HISTORIC AND DESIGN REVIEW COMMISSION

HDRC CASE NO: 2020-452
ADDRESS: 250 MARY LOUISE
LEGAL DESCRIPTION: NCB 6699 BLK 8 LOT 14& 15
ZONING: R-6, H
CITY COUNCIL DIST.: 7
DISTRICT: Monticello Park Historic District
APPLICANT: Gary Hudman/HUDMAN GARY S
OWNER: Gary Hudman/HUDMAN GARY S
TYPE OF WORK: Modification to previous approval
APPLICATION RECEIVED: October 01, 2020
60-DAY REVIEW: Not applicable due to City Council Emergency Orders
CASE MANAGER: Rachel Rettaliata

REQUEST:

1. Amend the previous HDRC approval to install two fixed arched windows instead of French doors on rear elevation.
2. Replace 3 existing windows on the rear elevation with aluminum-clad wood windows.

New Rear Windows to Match Current Rear Windows

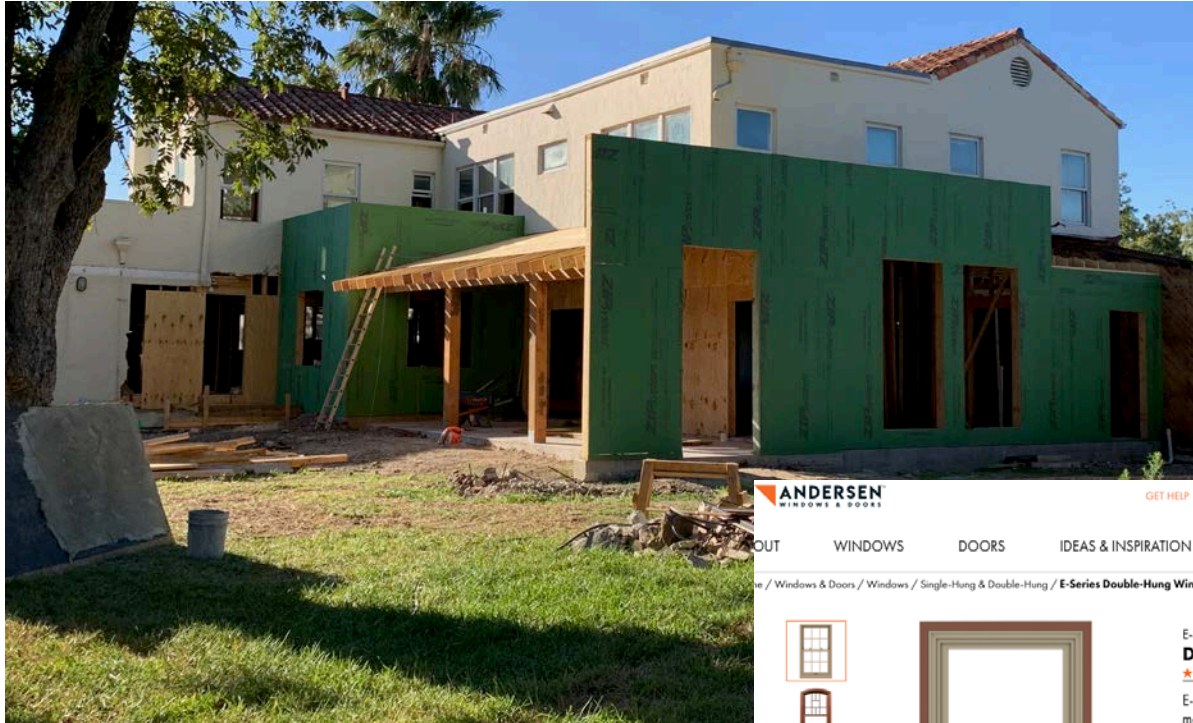
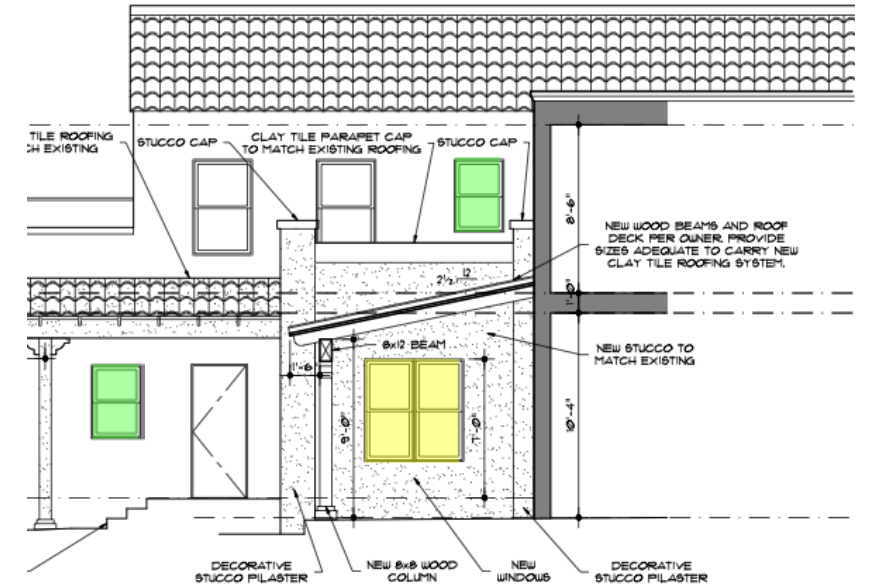
- d. REAR ADDITION: WINDOW MATERIAL – The applicant has proposed to install 4 new Anderson E Series aluminum clad double hung windows on the previously approved rear breakfast room addition. The windows proposed match 14 windows on the rear elevation. The breakfast room addition was approved by the HDRC in 2012 and staff finds the window product appropriate.

- e. FENESTRATION MODIFICATIONS: REAR ELEVATIONS – The applicant has proposed to replace 3 existing windows on the rear south and east elevations. Two of the existing windows proposed for replacement are located on the second floor, one on the south elevation and one on the east elevation. The existing windows are previous replacement windows circa 1991 and the original openings were modified to accommodate smaller bathroom windows. The applicant has proposed to return the window openings to the size of the historic openings and install Anderson E Series aluminum clad wood windows to match the rest of the windows on the rear elevation. The applicant has also proposed to replace the circa 1991 wood casement window on the first floor of the east elevation with an Anderson E Series aluminum clad wood window to match the existing windows on the rear elevations. Guideline 6.B.vii for Exterior Maintenance and Alterations states that non-historic incompatible windows should be replaced with windows that are typical of the architectural style of the building. Staff finds the proposal appropriate.

- 1) Anderson E-Series wood double hung. Aluminum clad. **Exact match** to current.
- 2) **Four Double Hungs** in new Breakfast Room addition, 2'6" x 5'0", as per approved plans
- 3) **Three Double Hungs** in 2 Bathrooms and Laundry Room. 2'6" x 3'4", same size as original openings

- i. That the applicant installs windows that are a wood or aluminum-clad wood product that meet staff's standard window stipulations. Final window material specifications must be submitted to staff for review and approval prior to the issuance of a Certificate of Appropriateness. The windows should feature an inset of two (2) inches within facades and should feature profiles that are found historically within the immediate vicinity. Meeting rails must be no taller than 1.25" and stiles no wider than 2.25". White manufacturer's color is not allowed, and color selection must be presented to staff. There should be a minimum of two inches in depth between the front face of the window trim and the front face of the top window sash. This must be accomplished by recessing the window sufficiently within the opening or with the installation of additional window trim to add thickness. Window trim must feature traditional dimensions and architecturally appropriate sill detail. Window track components must be painted to match the window trim or concealed by a wood window screen set within the opening.

Final Design for Arched Windows

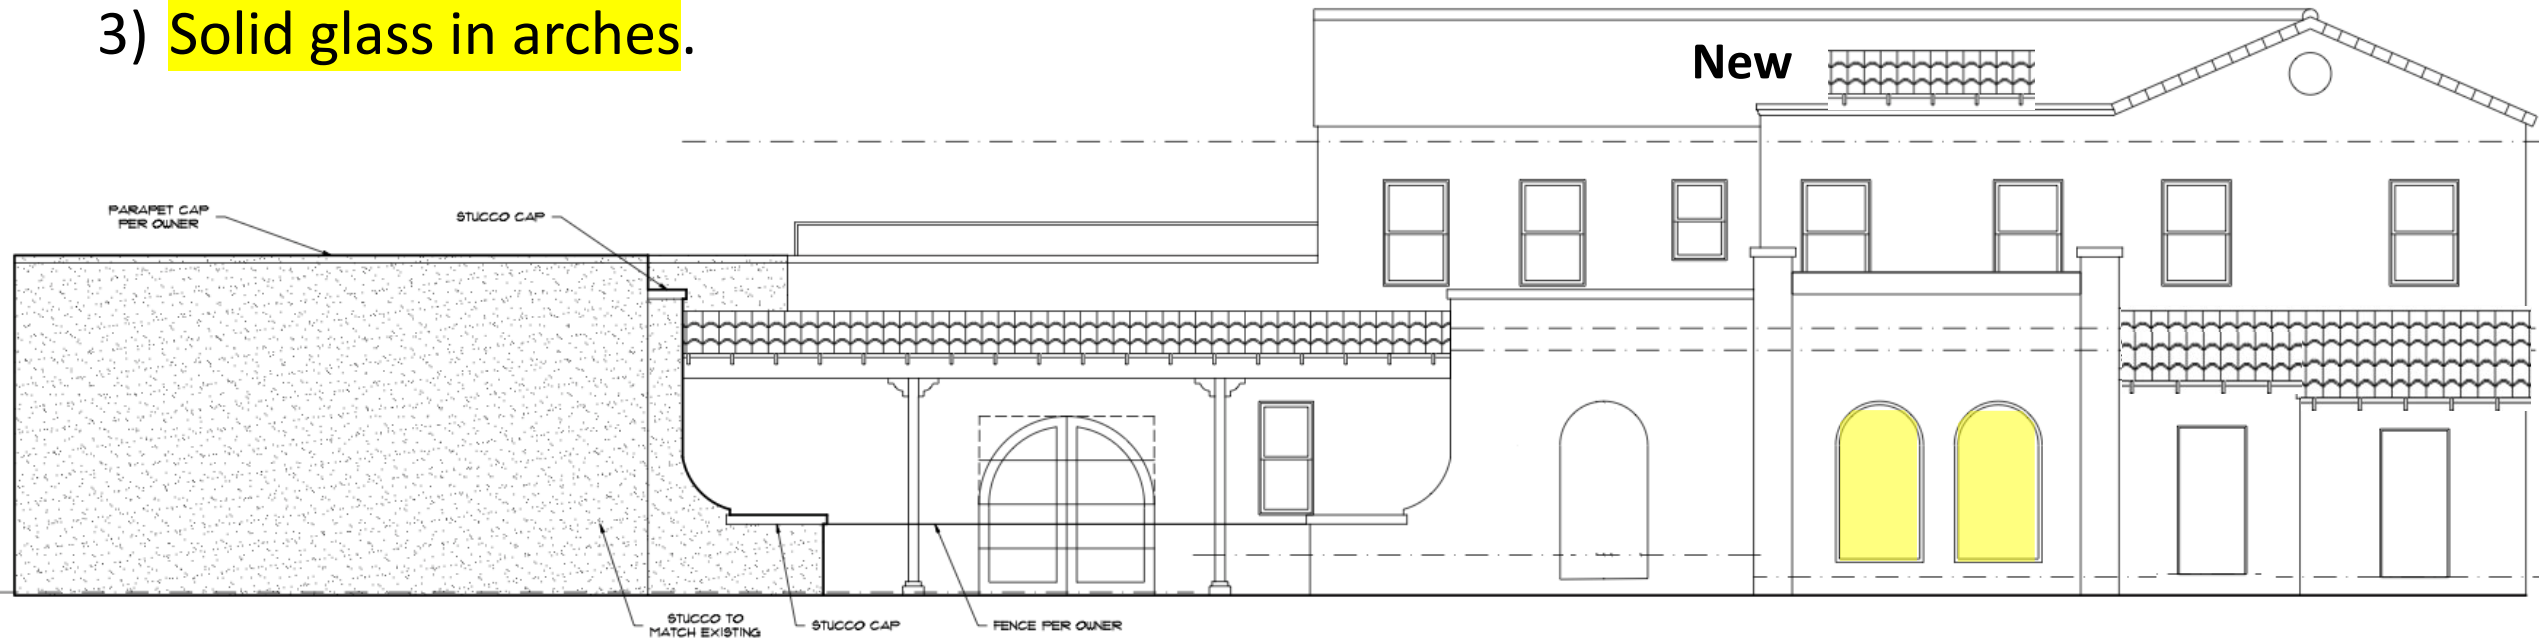
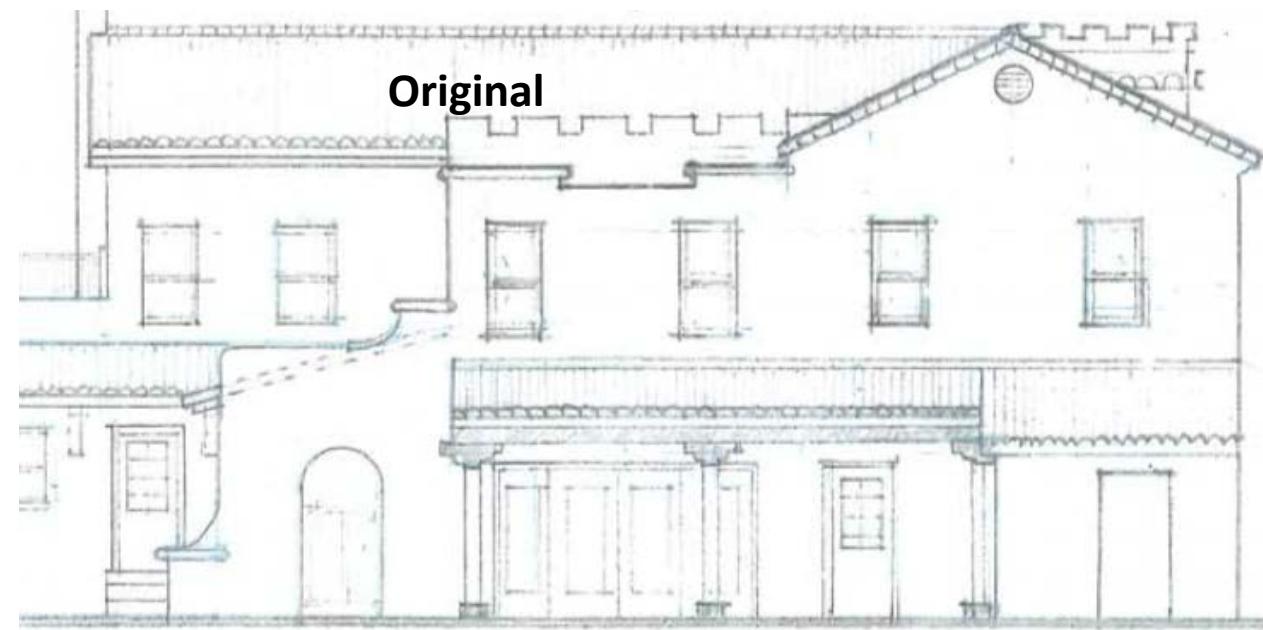
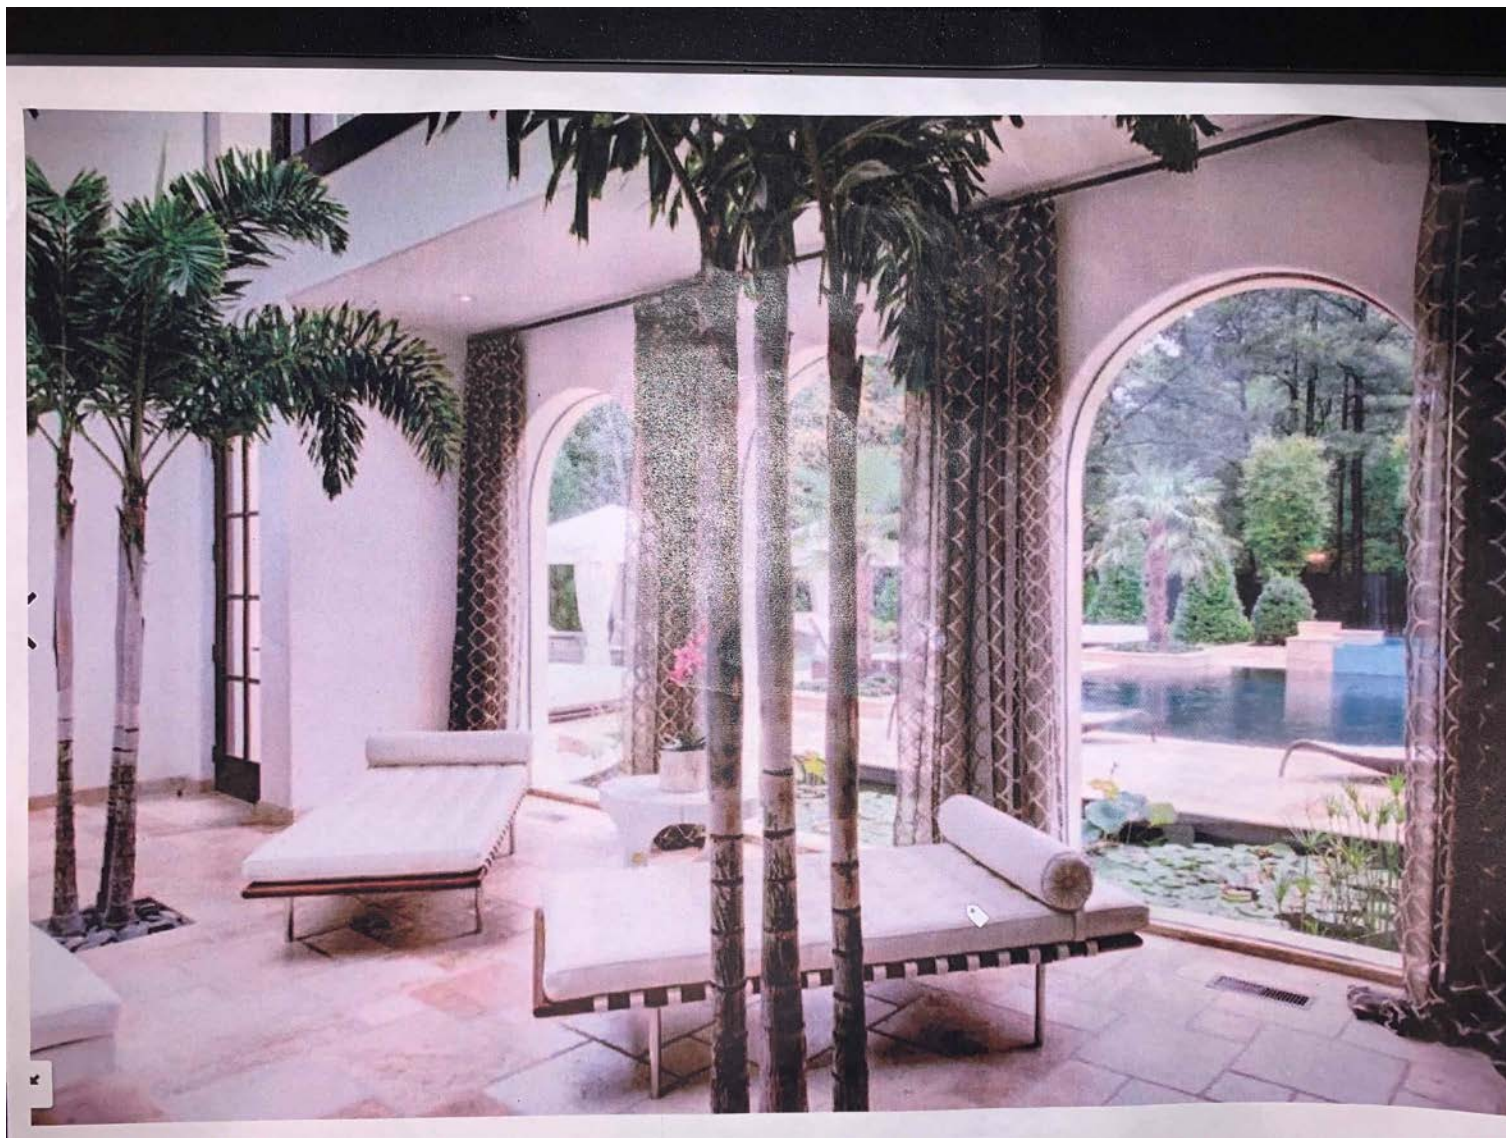
- c. REAR ADDITION: HDRC AMENDMENT – The applicant has proposed to install two fixed arched windows instead of the HDRC-approved French door installation on the east elevation facing the existing pool. Following the 2012 HDRC approval, it was determined that the existing circa 1991 French doors were deteriorated and that the location could not safely accommodate doors. The applicant has proposed to install Anderson E Series fixed arched windows. Guideline 6.B.iv for Exterior Maintenance and Alterations states that new windows should be installed to match the historic or existing windows in terms of size, type, configuration, material, form, appearance, and detail. Staff finds that the window proposal is appropriate.

- 1) Change from original approved plan: **Replace French doors with 2 arched windows.** Doors would open too close to pool and be a potential hazard.
- 2) Change allows ceiling to be full height in family room, versus original plan with sloped ceiling and roof.
- 3) **Solid glass in arches.**

Staff recommends approval of items 1 and 2 based on findings a through e with the following stipulation:
